COUNCIL BRIEFING & ASSESSMENT REPORT

NORTHERN REGIONAL PLANNING PANEL

PANEL REFERENCE & DA NUMBER	PPSNTH-297 – DA21/0949.01
PROPOSAL	Section 4.55(2) modification to Seniors Housing development for demolition of existing dwelling and construction of 95 residential units, a swimming pool, signage, lot consolidation and tree removal.
ADDRESS	Lot 113 DP 237806; 6 Powell Street, Tweed Heads; Lot 114 DP 237806; 8 Powell Street, Tweed Heads; Lot 115 DP 237806; 10 Powell Street, Tweed Heads; Lot 116 DP 237806; 12 Powell Street, Tweed Heads; Lot 117 DP 237806; 33 Florence Street, Tweed Heads; Lot 118 DP 237806; 35 Florence Street, Tweed Heads; and Lot 119 DP 237806; 37 Florence Street, Tweed Heads
APPLICANT	Zone Planning
OWNER	Tweed Shire Council
DA LODGEMENT DATE	16 February 2024
APPLICATION TYPE	Section 4.55(2) Modification Application
REGIONALLY SIGNIFICANT CRITERIA	<p>The original application was determined pursuant to Section 2.19, Schedule 6 of State Environmental Planning Policy (Planning Systems) 2021: development that has a capital investment value of more than \$30 million.</p> <p>The proposed modification comprises of a departure from the development standard pursuant to Clause

Figure 7A: Proposed amended site plan (with staging detail – Stage 1)

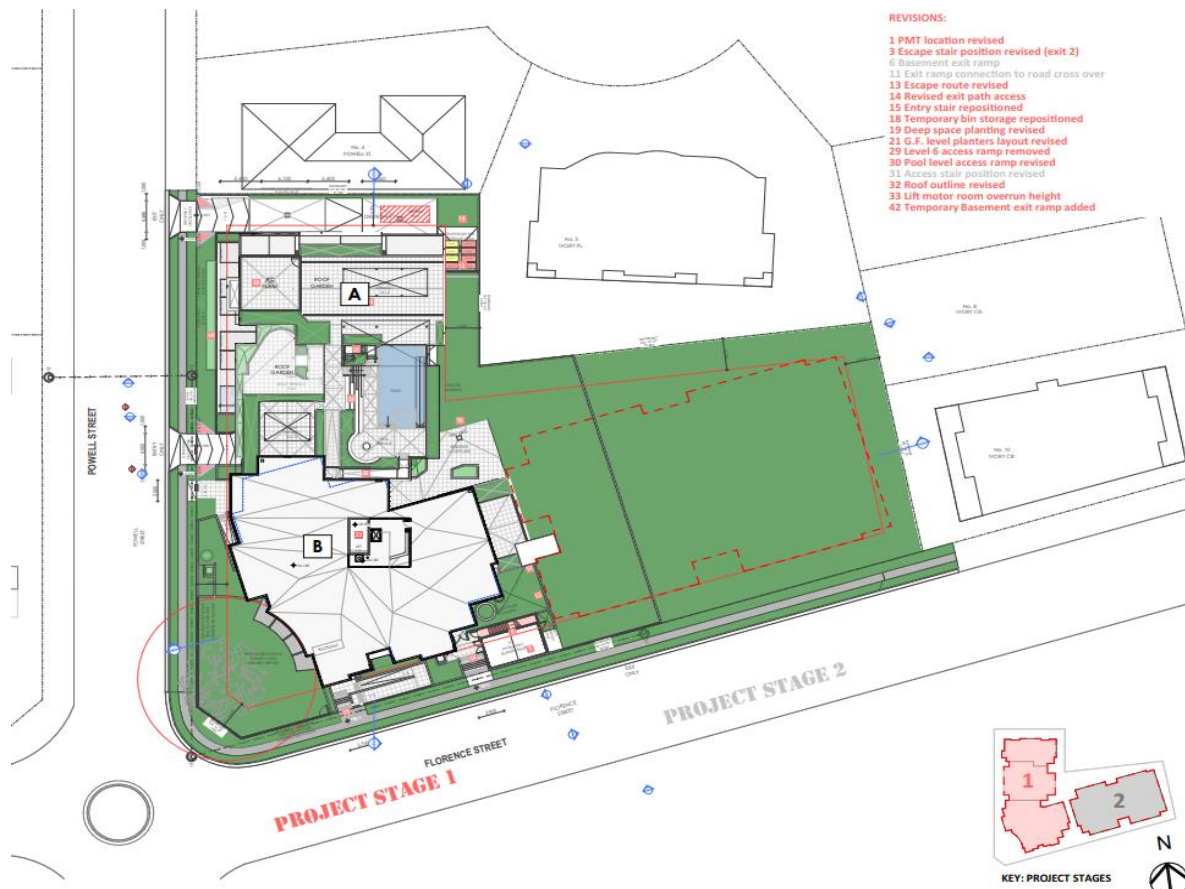
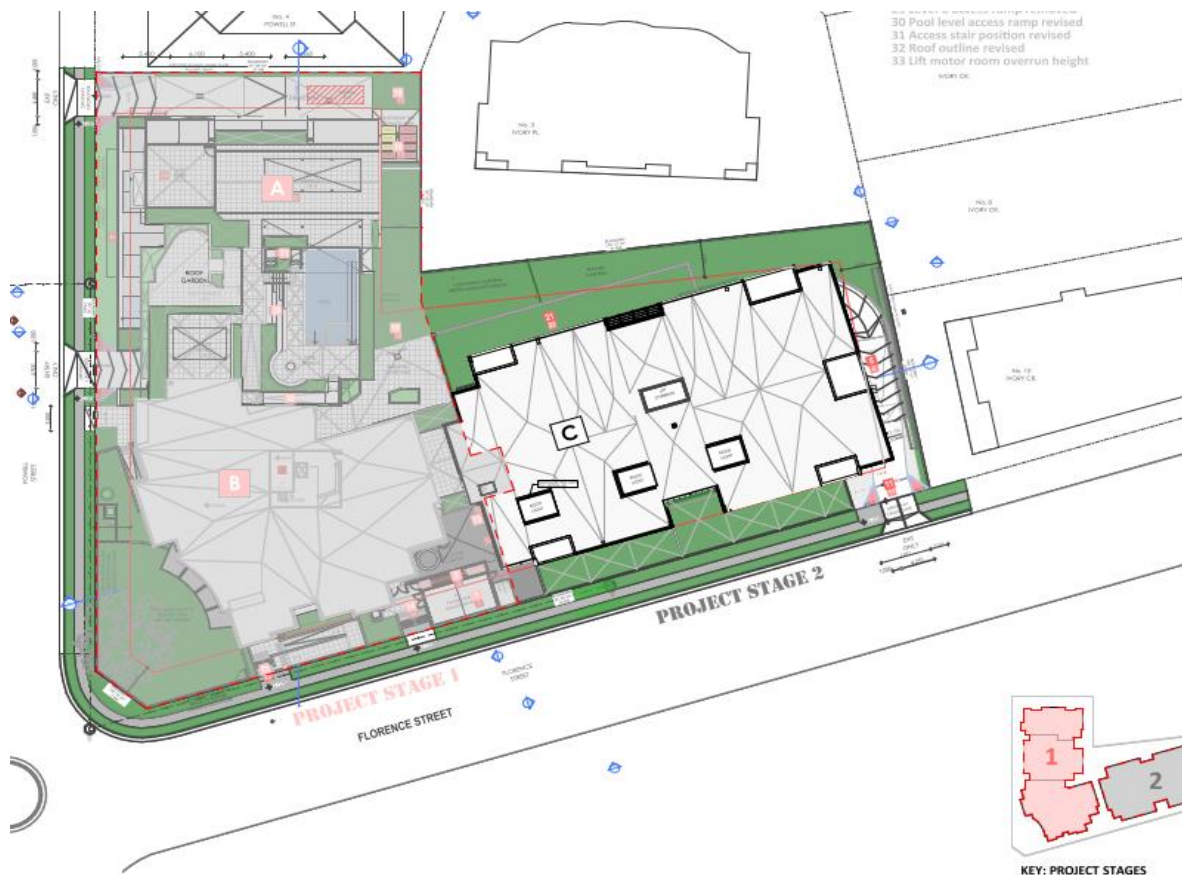
The proposed modification seeks to alter the staging of the development to enable Building A and B to be constructed at Stage 1 and Building C to be constructed at Stage 2. The demolition plan makes provision for all existing dwellings to be demolished as part of Stage 1 works. Whilst not explicitly outlined in the DA, the lot consolidation would likely be reflective of the amended staging. The number of parking space, the FSR, deep soil zones and landscape areas remain largely unchanged as a result of the proposed modification.

The proposed modification will seek an alteration to access for the site given that Stage 2 egress to Florence Street is not available during Stage 1 of the development. As such, in/out access is proposed via Powell Street via two separate single crossovers. The singular vehicular ingress to the development will be provided via a one lane, one way driveway crossover from Powell Street from the northwestern boundary of the development site which will provide access to the ground level parking and the basement. Egress will be provided via the northwestern driveway/crossover to Powell Street, per **Figure 9** below:

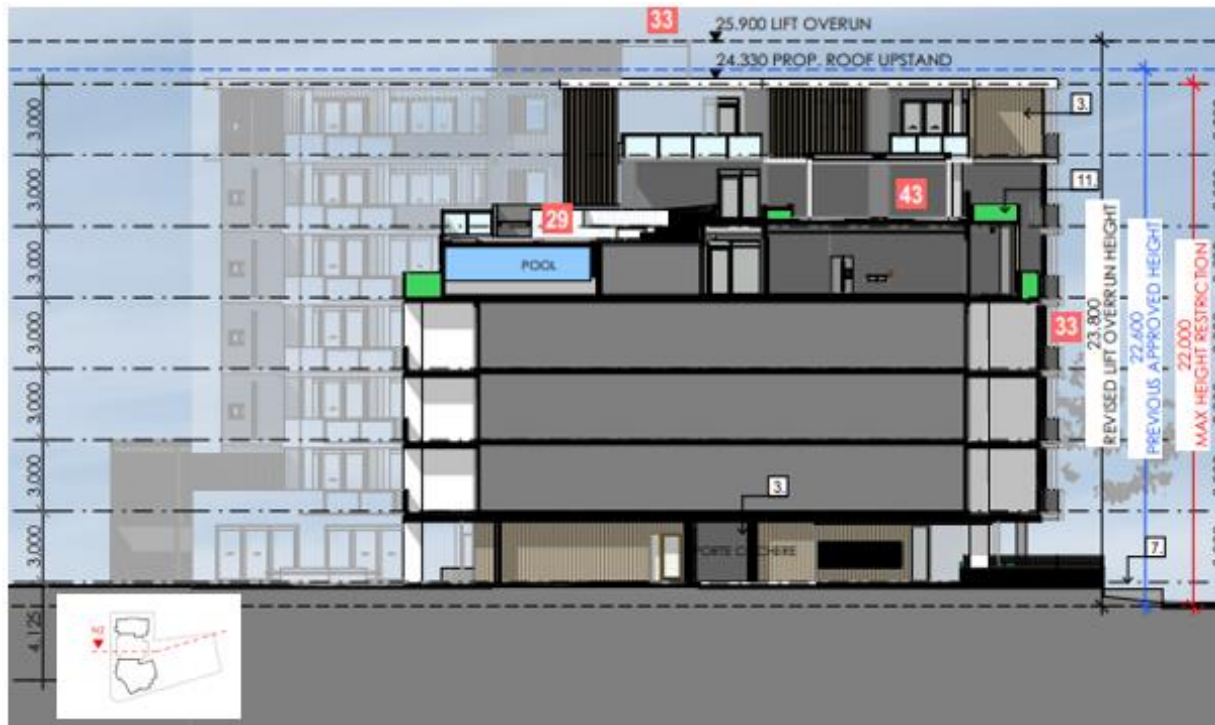
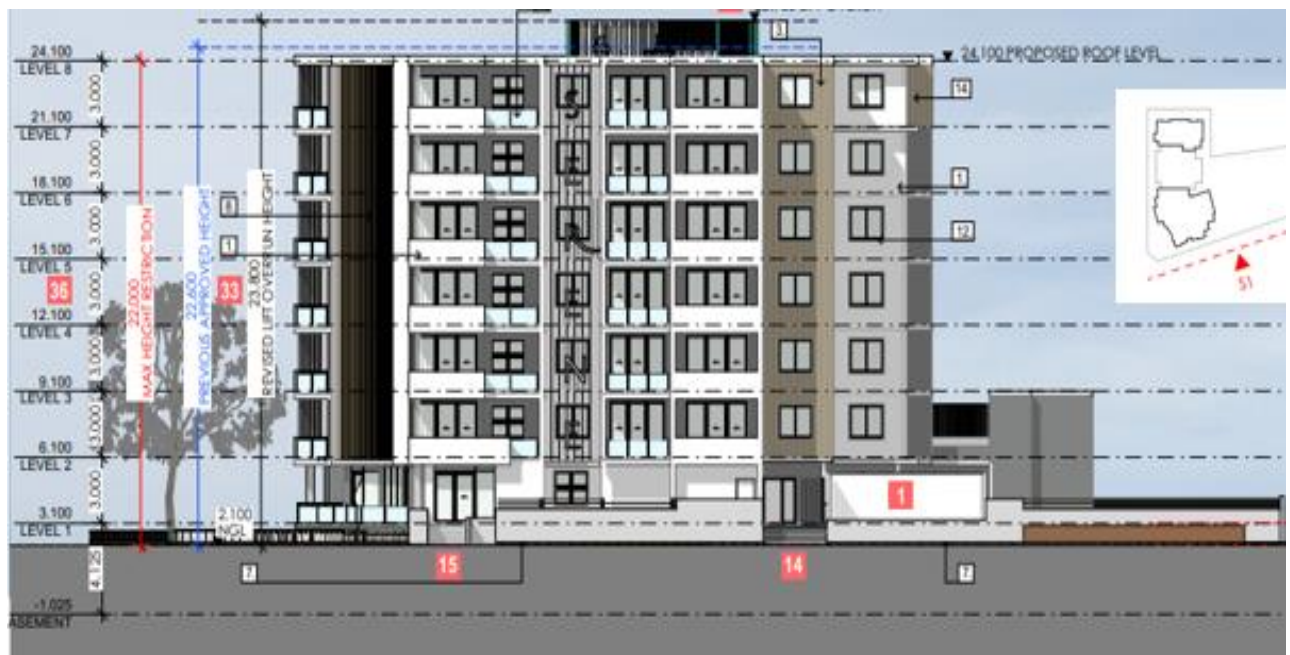
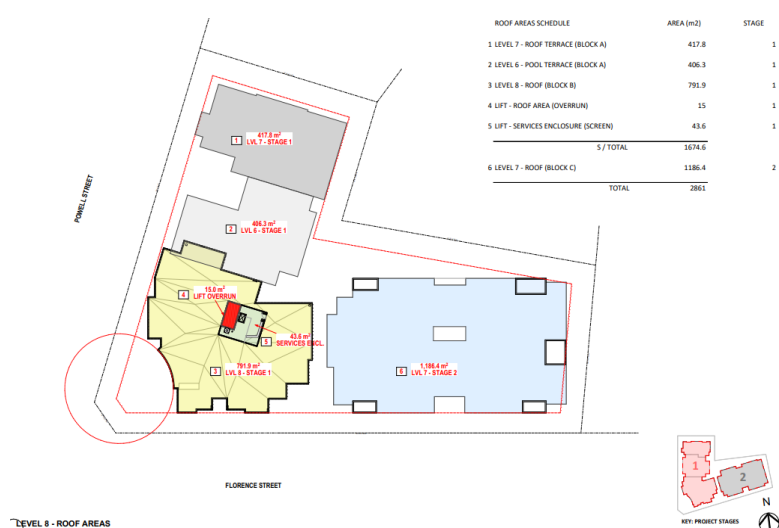
The series of images below provide a comparative study of the proposed elevations for Building B (proposed to be constructed in Stage 1), which contains exceedance for lift overrun vs approved elevation of Building B (noting that the maximum exceedance is observed at the Eastern elevation).

Figure 10: Diagram submitted by the proponent to demonstrate the additional variation to overall building height within Building B

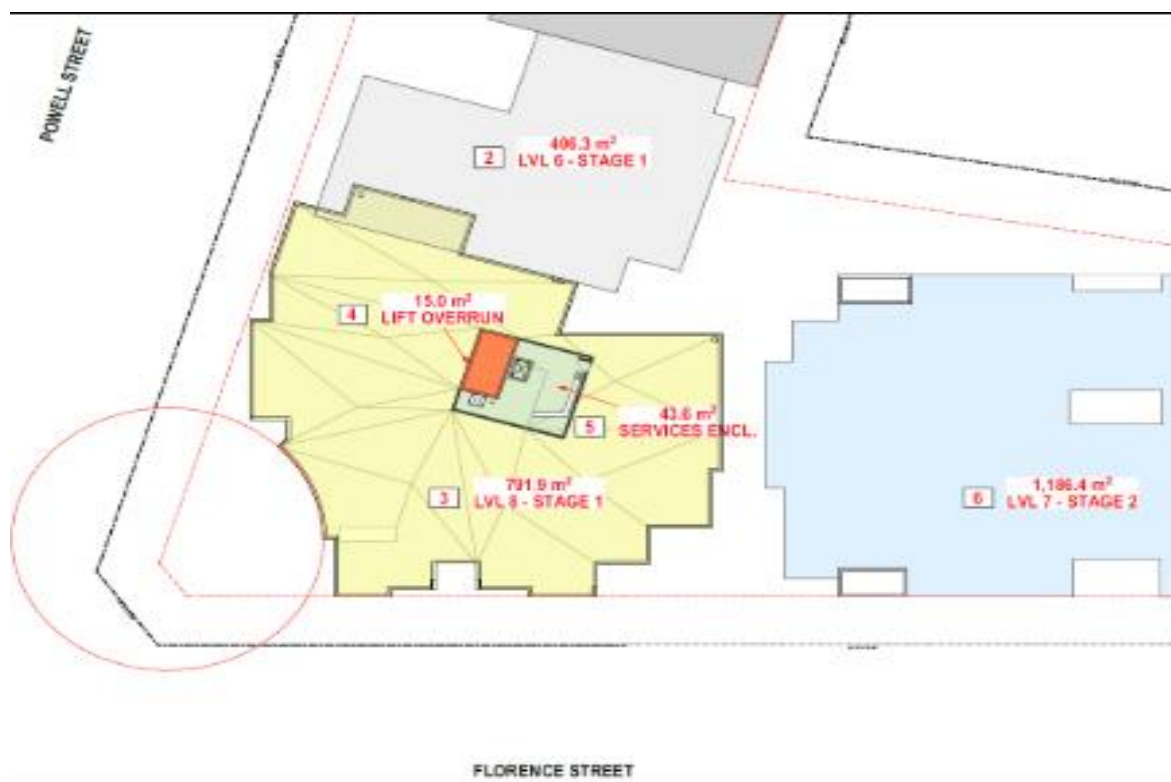
Figure 10 below is replicated from the modification report as it aims to illustrate the additional variation to overall building height within Building B which forms part of Stage 1 of the development:

Whilst the lift overrun may be marginally visible from the street, the location of this aspect of the building is such that it is centralised in the buildings floorplate and the massing is setback from the street. Therefore, having regard to the overall maximum height of buildings permitted in this location, the provision of 1.8m excess in height for such a marginal horizontal plane of built form is likely to be inconceivable at the human scale and therefore would not have streetscape impacts.
